To: Ms. Debra Rossi, RPM (USEPA Region III)

From: Theresa Miller, PG, LSP (Golder) and Michele Ruth, PE (RAI)

Date: June 1, 2018

RE: Response to Comments on Work Plan for Additional Investigation
Army Creek Landfill, New Castle County, Delaware

ATTACHMENT 2, FIGURE 2-1 (NEW)

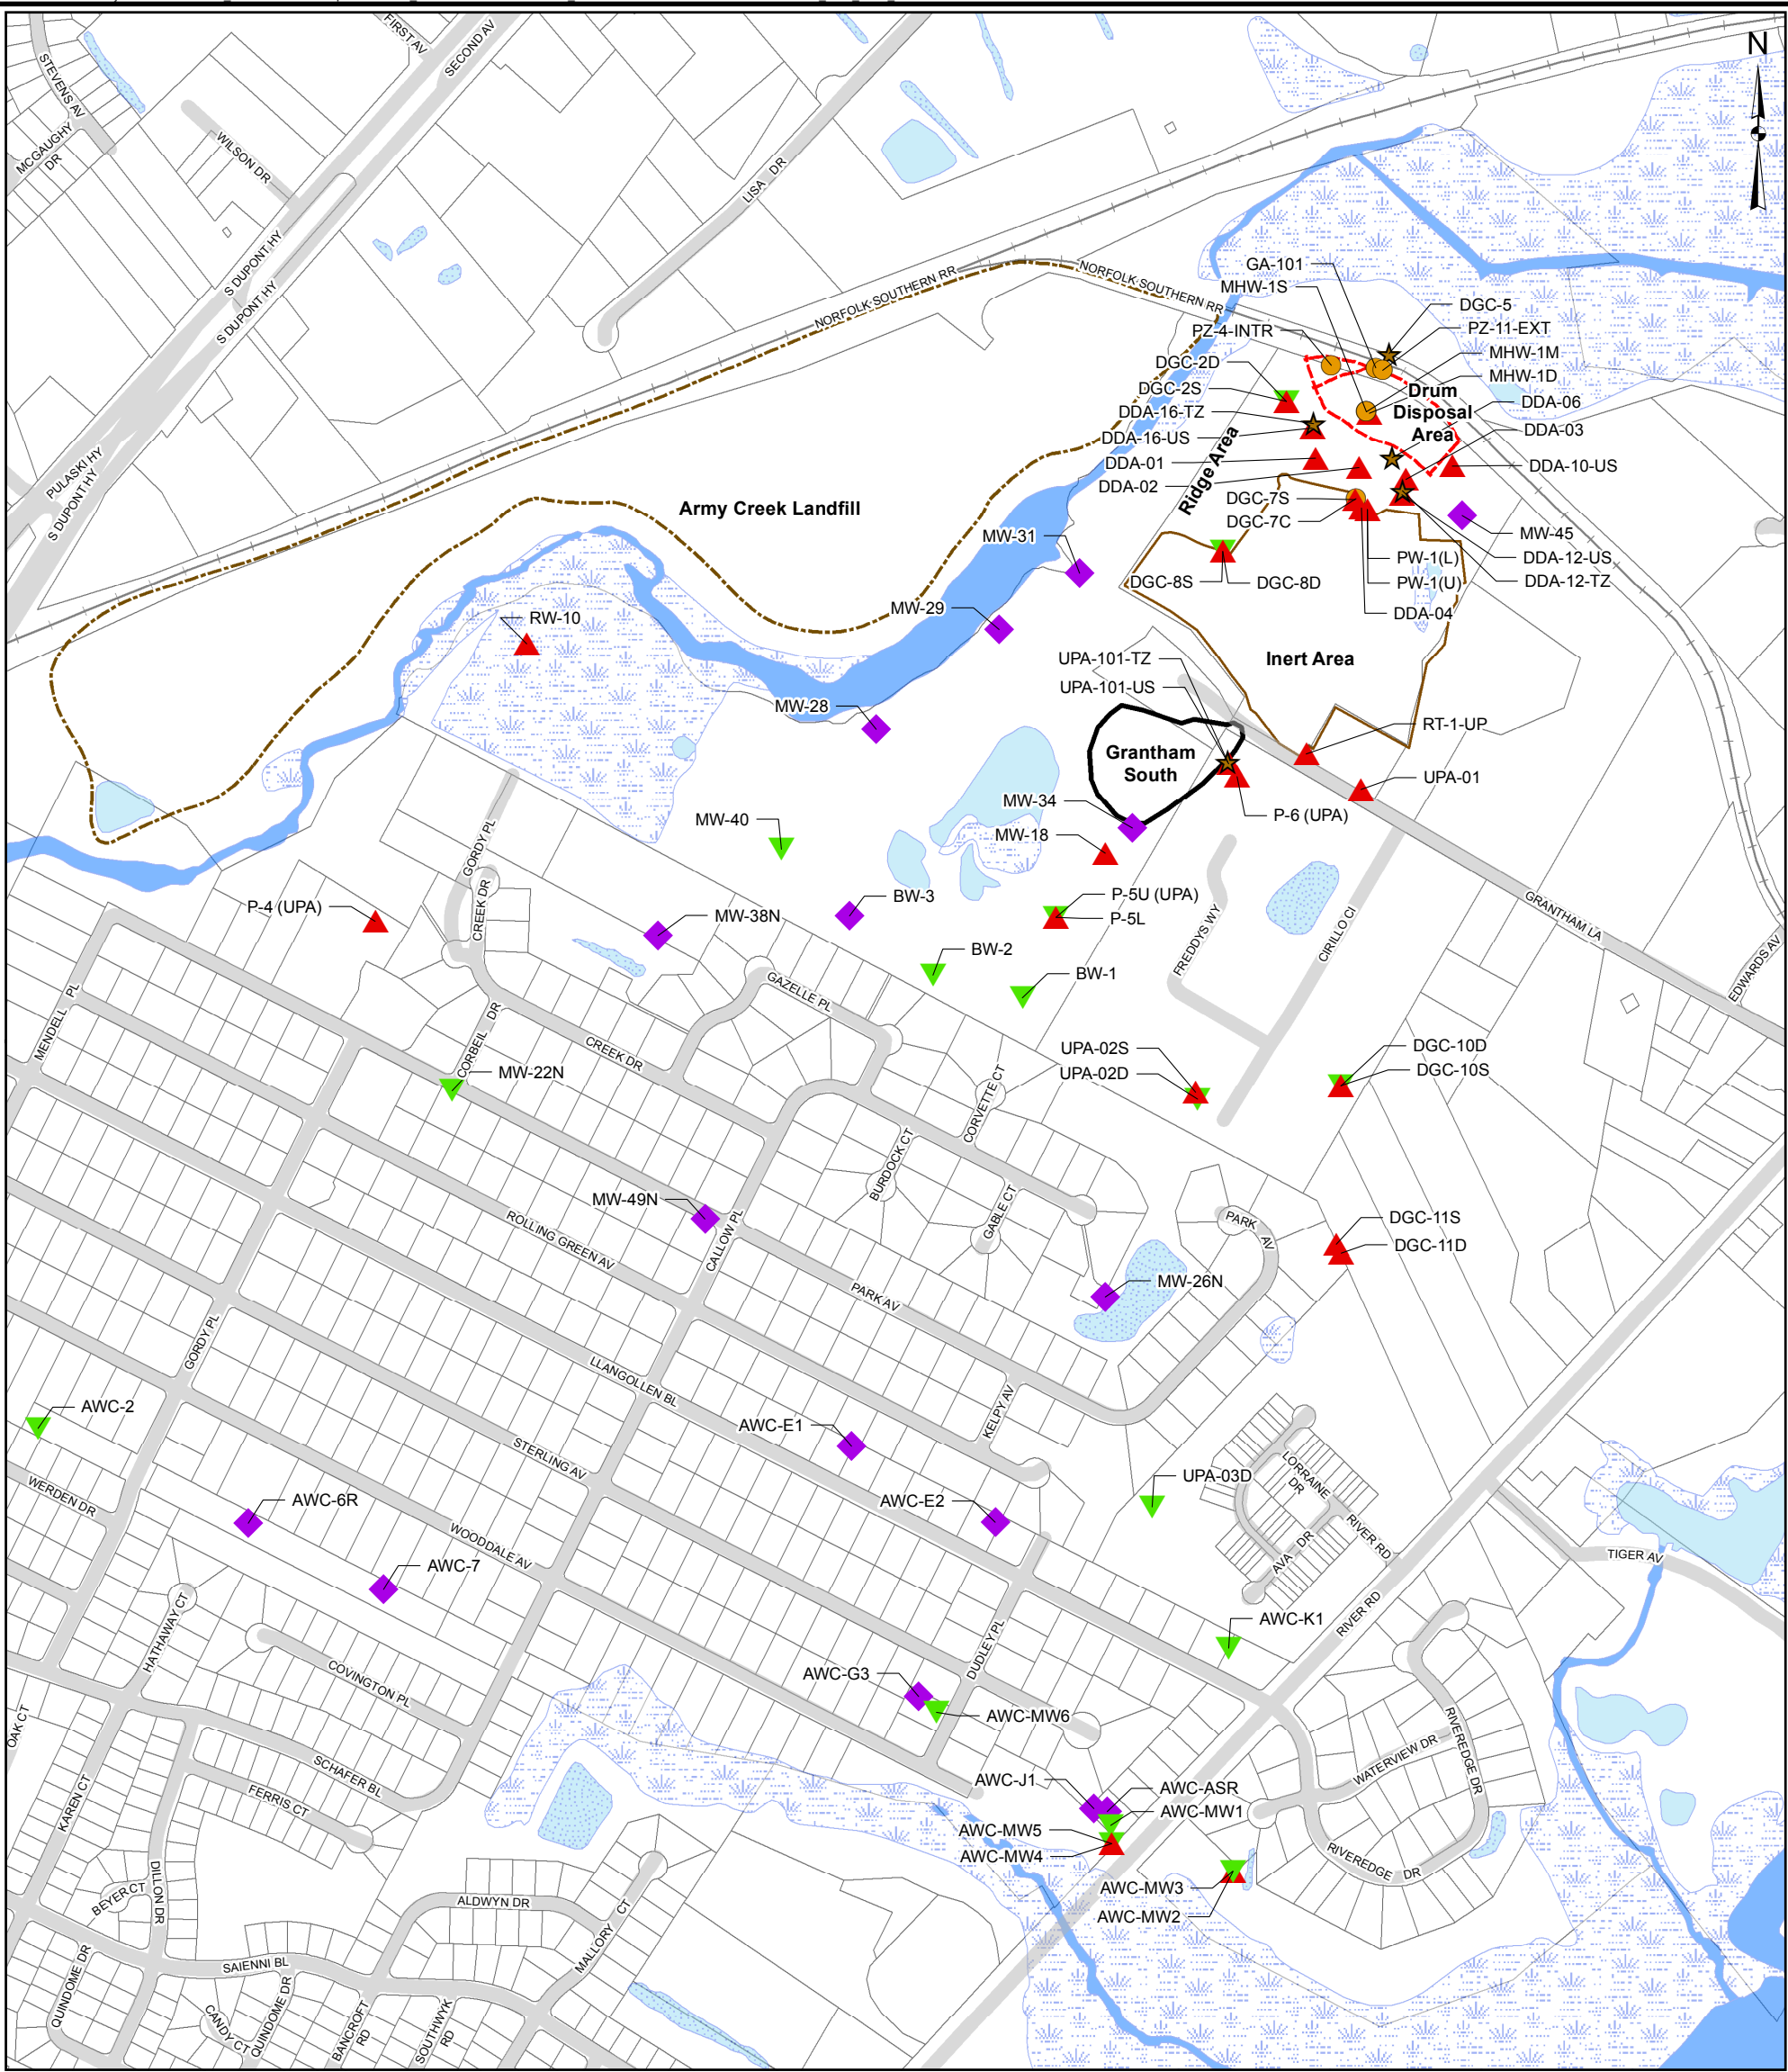
USEPA/DNREC Comment 1. Background: The last paragraph discusses PFAS data in Attachment 2. A figure presenting the locations of the Attachment 2 sampling results should be include[d].

As requested, a figure (Attachment Figure 2-1) presenting the locations for the PFAS monitoring results provided in Attachment 2 of the Work Plan has been prepared and is attached. This figure will be included in revised Work Plan.
